Service Bulletin

MODEL: FDR-AX53.

No. E58409851

Subject: Cannot record / play back 4K movie

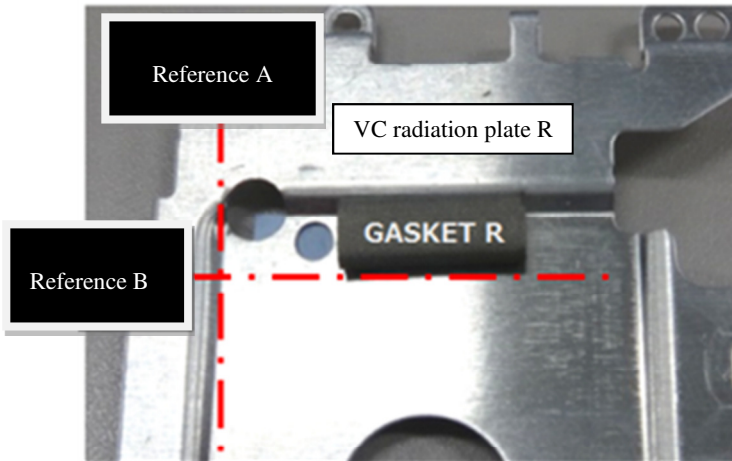
Contact of the lens block or the tripod block to the VC Board may damage the solder portion of the IC.

When replacing the VC board, attach sheet (0826)F to VC radiation plate R and attach sheet(0907)F to VC board by referring to the following figure which is described about the attachment position.

- Attachment of sheet(0826)F to VC radiation sheet R

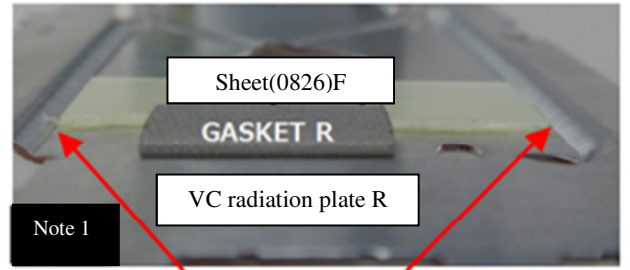
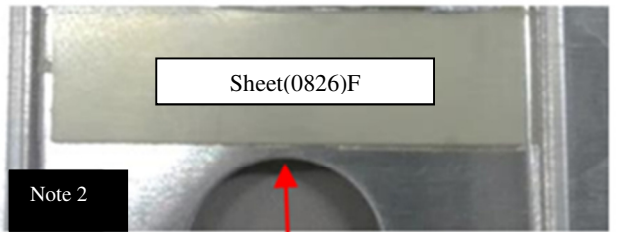
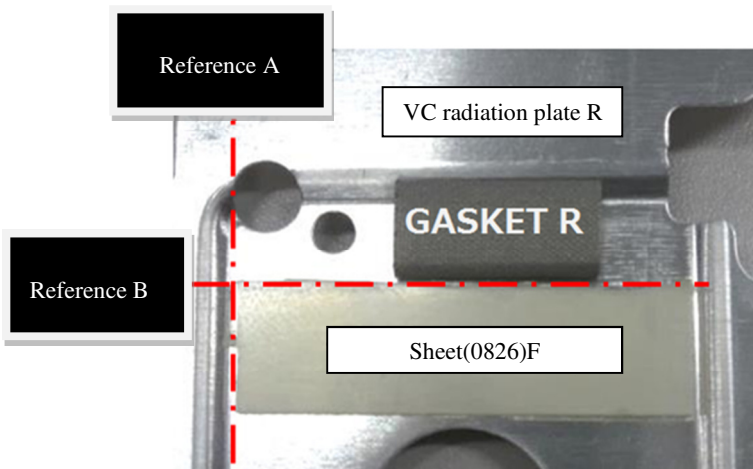
- Reference A: Alignment with the left end of the hole of VC radiation plate R
- Reference B: Alignment with the bottom end of GASKET R

Sheet would not ride on slopes.

Sheet would not block hole.

■ Attachment of sheet(0907)F to VC board

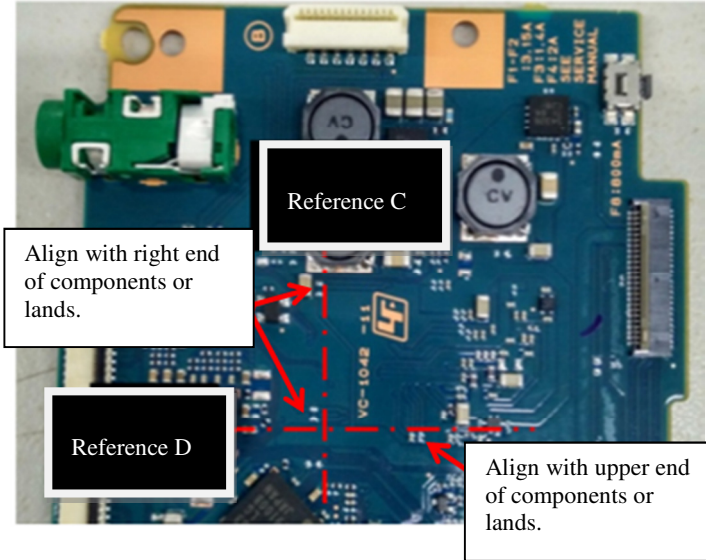
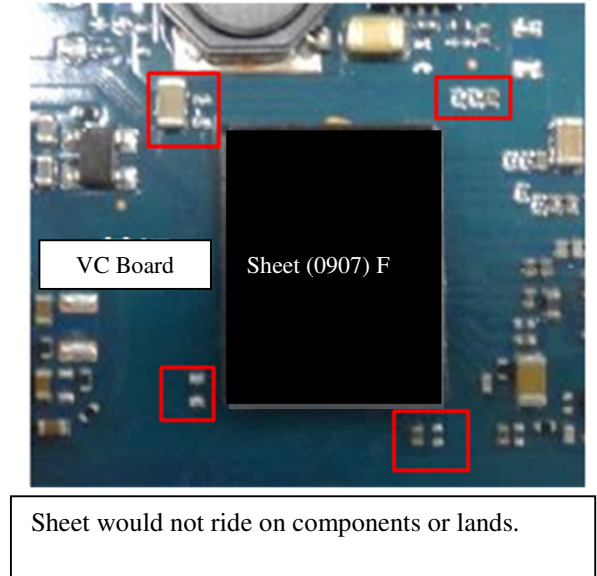
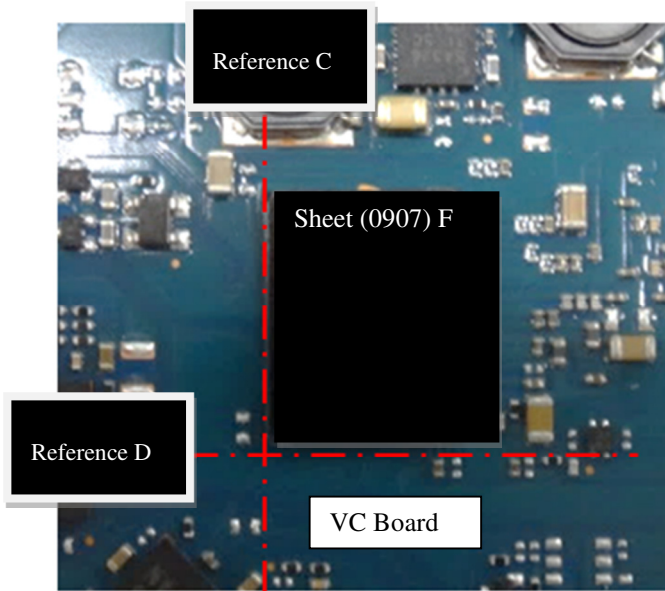
- Reference C: Alignment with the right end of chip, land
- Reference D: Alignment with the upper end of chip, land
